CHAPTER 9

RESPONSE TO COMMENTS

The Response to Comments chapter of the EIR includes comment letters for the Loperena Minor Use Permit/Coastal Development Permit Environmental Impact Report (EIR). These comment letters were received from entities including federal and state agencies, non-agency organizations, and the general public. In accordance with California Environmental Quality Act (CEQA) Guidelines §15132(d), this Final EIR presents the County of San Luis Obispo's (County's) response to comments submitted during the Draft EIR review and consultation process.

Subject: Loperena Minor Use Permit / Coastal Development Permit DRC2005-00216; ED06-317
SCH#: 2007081044

Figure 1: Cleath-Harris Geologic Map

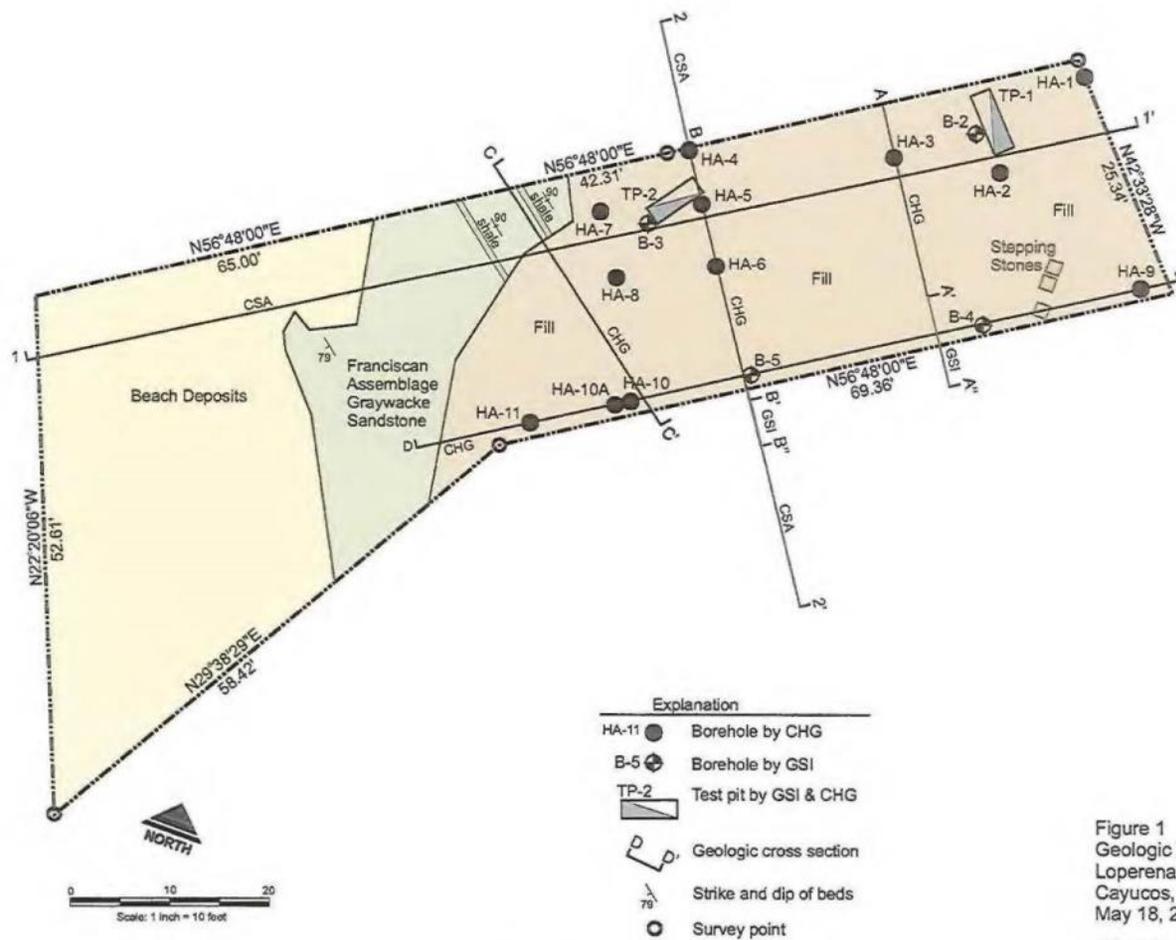
Figure 1 shows Cleath-Harris's Geologic Map of the site that clearly shows exposed bedrock (Franciscan Assemblage Graywacke sandstone) across the entire width of the property along the coastal bluff face, with Beach Deposits seaward of the bedrock.

Figure 2: Cleath-Harris Geologic Cross Section D-D' Modified to Show Coastal Bluff and Beach

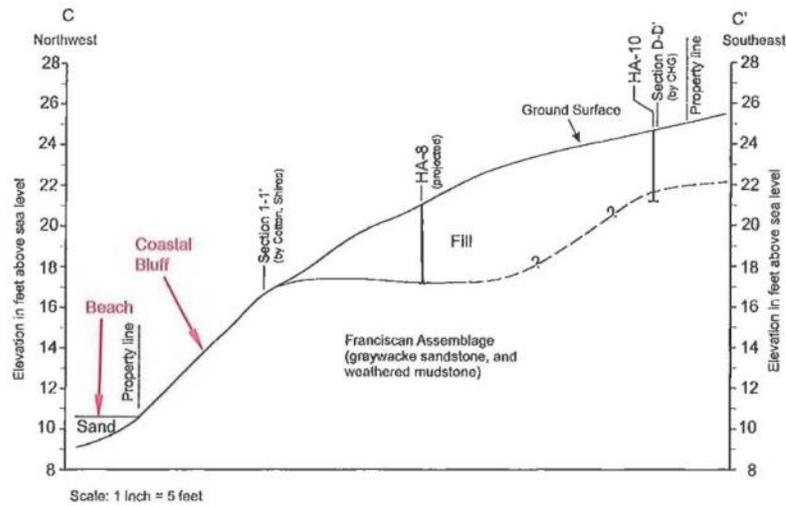
Figure 2 shows Cleath-Harris's Cross Section D-D'. The applicant's geologist (Cleath) terminated this cross section at elevation 16 and did not extend it down the near vertical bedrock coastal bluff face down to the beach. This cross section shows a thin mantle of fill covering the bedrock on the inland portion of the lot. We have sketched an extended portion of the cross section below elevation 16, to show the coastal bluff face and beach that exists there.

Figure 3: Cleath-Harris Geologic Cross Section C-C' Modified to Show Coastal Bluff and Beach

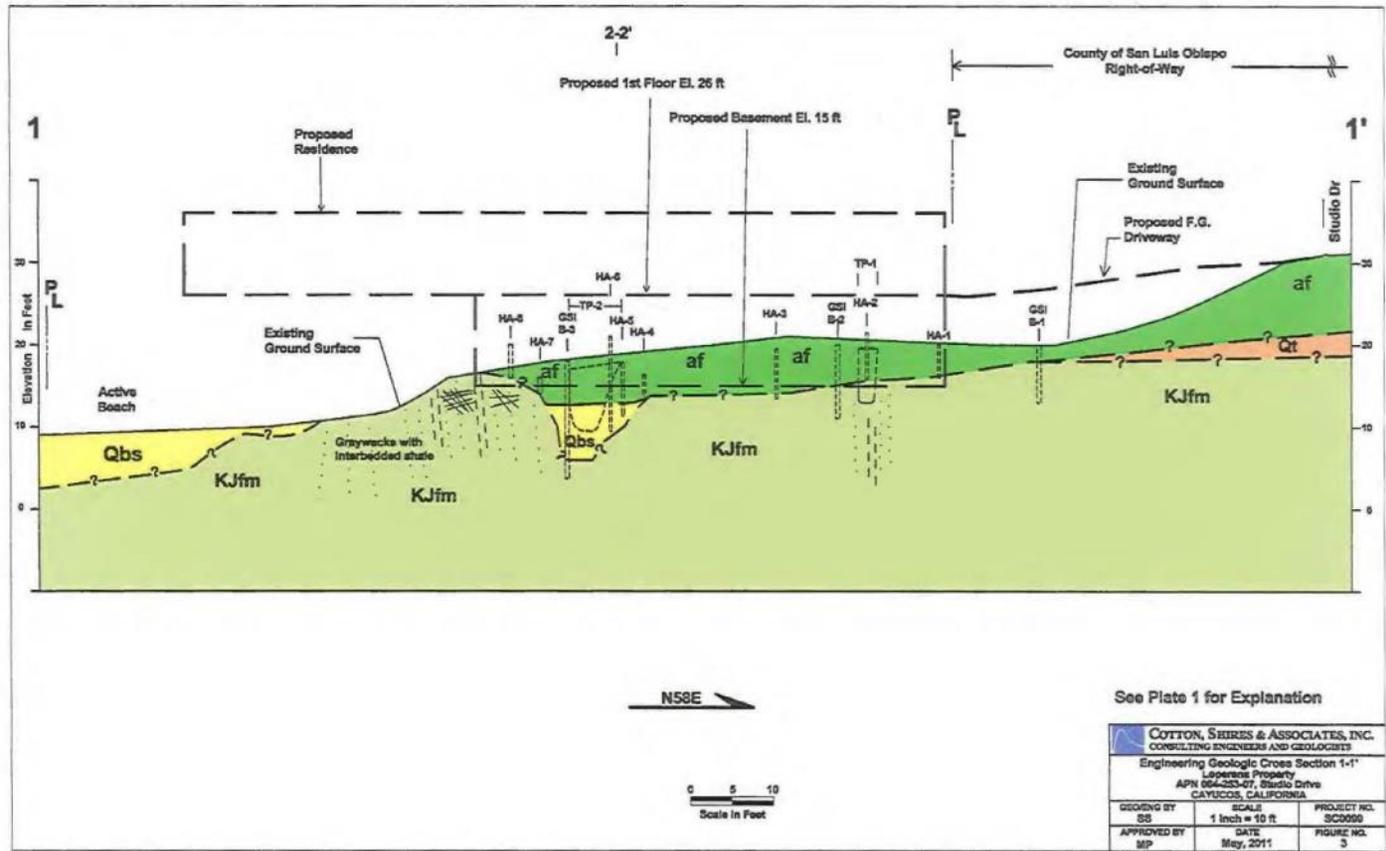
Figure 3 shows Cleath-Harris's Cross Section C-C'. Cross Section C, which is located at the upcoast property boundary, shows that the bluff face is composed of exposed Franciscan Assemblage Bedrock from the sandy beach up to about Elevation 17. The bedrock is mantled by 3 to 4 feet of fill. In fact, as depicted by the applicant's geologist, the bedrock under the fill extends up to elevation 22, and one could argue that the fill is covering what was once the coastal bluff face between elevation 17 and 22. We have labeled the cross section to show the coastal bluff face and beach that exists there.

Figure 5: Cotton Shires 1937 Aerial Photo Features. Their Interpretation of Coastal Bluff.

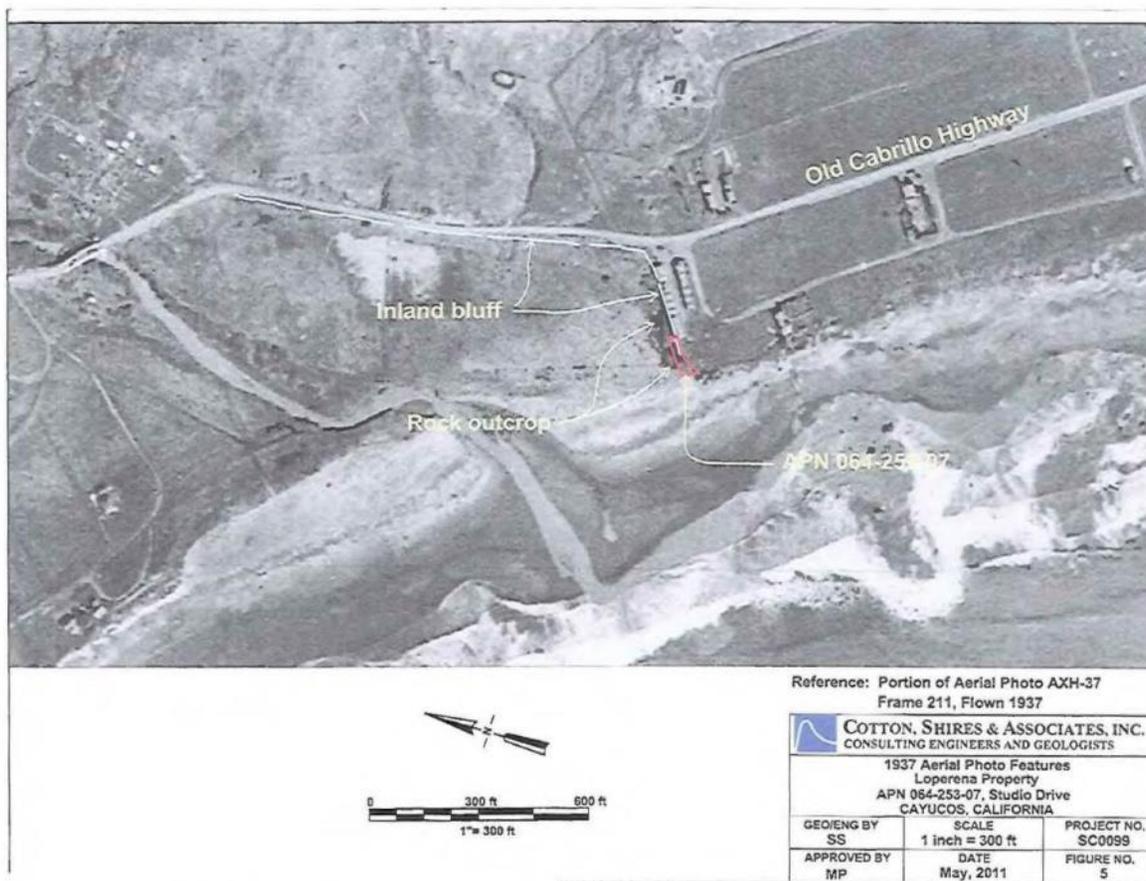
Figure 5 is a figure from Cotton Shires & Associates report dated May 31, 2011. It is a portion of a 1937 aerial photo that they have interpreted to show an inland bluff line that was formed by Old Creek. This bluff line pre-dates the bluff line that exists since Highway One was constructed in its present alignment circa 1960.

Figure 7: State of California Acquisition Map from 1955 showing the Toe of Bluff that existed on the Loperena property in 1955

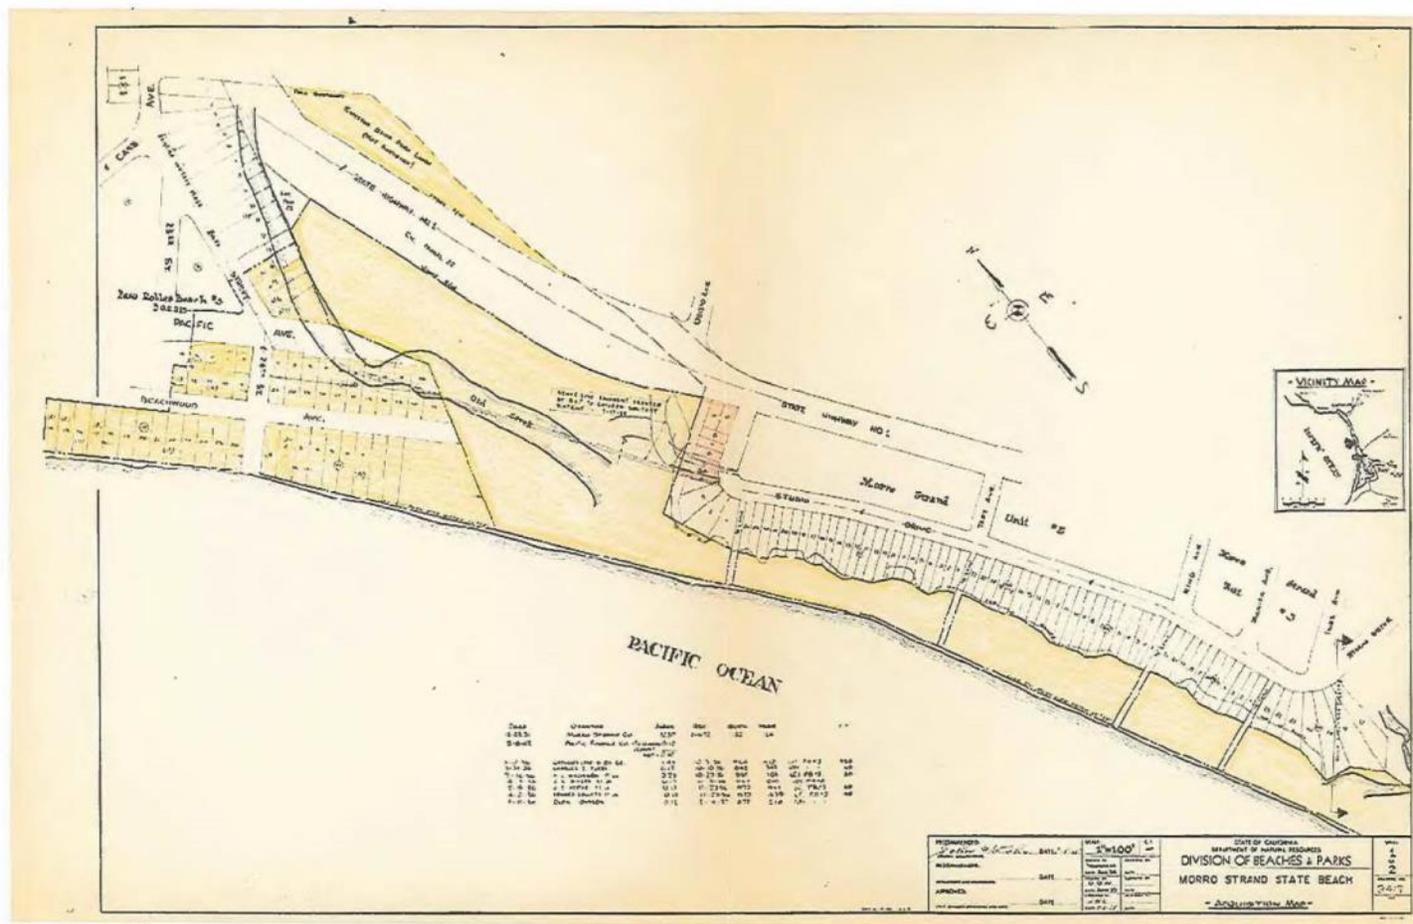
Fortunately, site specific mapping of the bluff was done in 1955. Figure 7 is a 1955 State Of California Acquisition Map for Morro Strand State Beach. This map shows the Loperena property and the bluff configuration at that time. Cotton Shires and Cleath-Harris make no reference to this map (included in this report) in their reports.

Figure 8: Enlarged Portion of State of California Acquisition Map from 1955 showing the Toe of Bluff that existed on the Loperena property in 1955

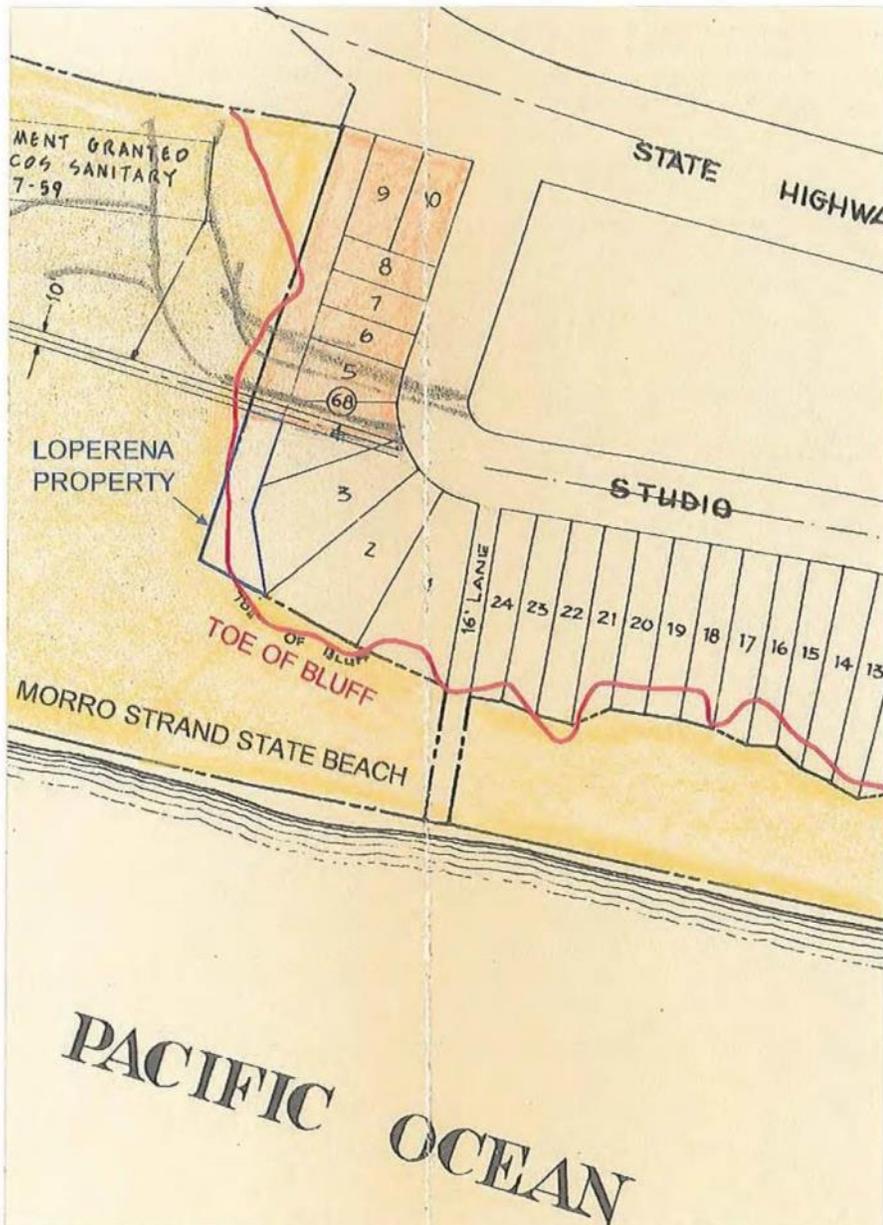
Figure 8 is an enlarged portion of State of California Acquisition Map from 1955 showing the toe of bluff that existed then on the Loperena property. The Loperena property was impacted by both the ocean and creek before Highway 1 was built, and now is primarily impacted by the ocean because the creek's alignment was altered. The map depicts that in 1955 (before Highway 1 was constructed in its present day alignment) it might be considered as a "corner lot", which is within a transition area that is part coastal bluff and part inland bluff. If it was partly a coastal bluff then, and is impacted by coastal processes such as marine erosion, ocean wave run-up, and wave impact today, it should be considered a coastal bluff.
